## **Access Compliance Report Public Rights-of-Way** (Curb Ramps)

Intersection ID: 29156 Main Street: BRANSCOMB DR **Cross Street: BRIDGEVILLE LN** Location: SW ADA ID: 79BB782D0626 Ramp Type: PerpDiag Initial Pass/Fail: Fail **Overall Compliance: No Severity Score:** 12.5

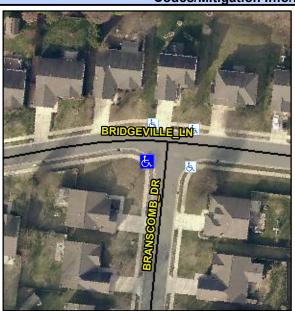
Possible Solutions: Remove & Replace Curb Ramp With Two New Directional Ramps or Equivalent. Surveyor Notes: N/A PROW/ADA: Not Found, R304.2.2
